**BUILDING DIVISION - ZONING SECTION
SITE PLAN REVIEW FORM**

DATE: March 27, 2025
TO: Samantha Yeung, Planner II
FROM: Karen Cree, Senior Zoning Examiner
RE: **Comments for Application No.:** **D02-20009 (ZBLA) Sub #1**
Related File: D06-22047 (Site Plan)
Applicant: GOLDBERG GROUP
Location: 13572 AND 13586 Bayview Avenue
Pt. Lot 1, Plan 200

The subject lands are proposed to be rezoned to "Multiple Residential One (RM1)" with exceptions and "Environmental Protection Area Two (EPA2)" under By-law 313-96 as amended, to facilitate the construction of an 10 storey residential building. I have reviewed the draft by-law submitted with this circulation against the submitted drawings and offer the following comments:

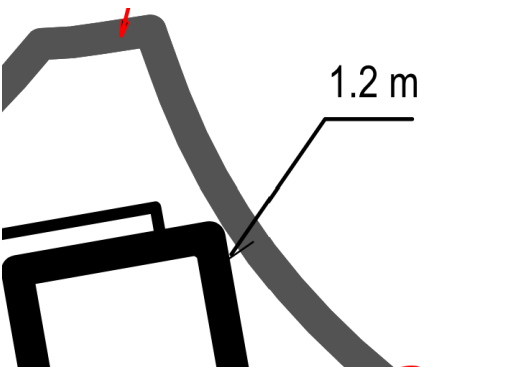
1. *The dimension lines are difficult to interpret due to the thickness of the linework on Schedule "B". In addition, there are several internal building lines shown on the drawing without any setback requirements. I suggest that the line thickness be reduced and any unnecessary lines be removed to simplify the Schedule.*
2. *There appear to be some required setbacks missing on Schedule "B" (please see below):*

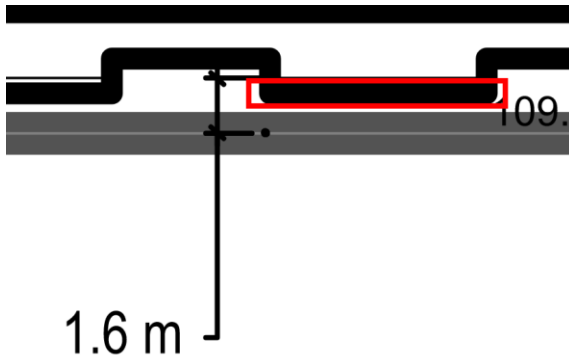
3. *Please confirm where the setback dimensions are for the required setback shown on Schedule "B" below:*

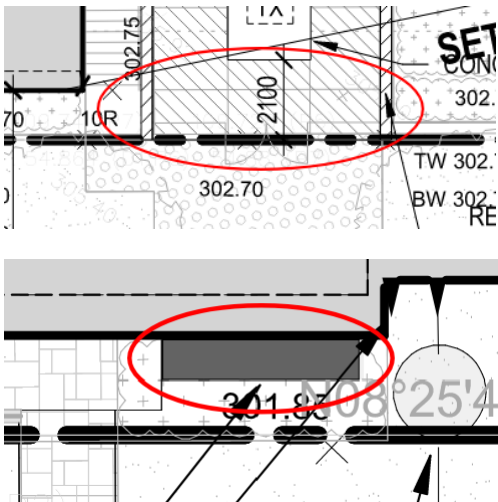
4. *The architectural projections and façade treatment encroachments should not be shown on Schedule "B" as it appears to be a building setback (see below):*
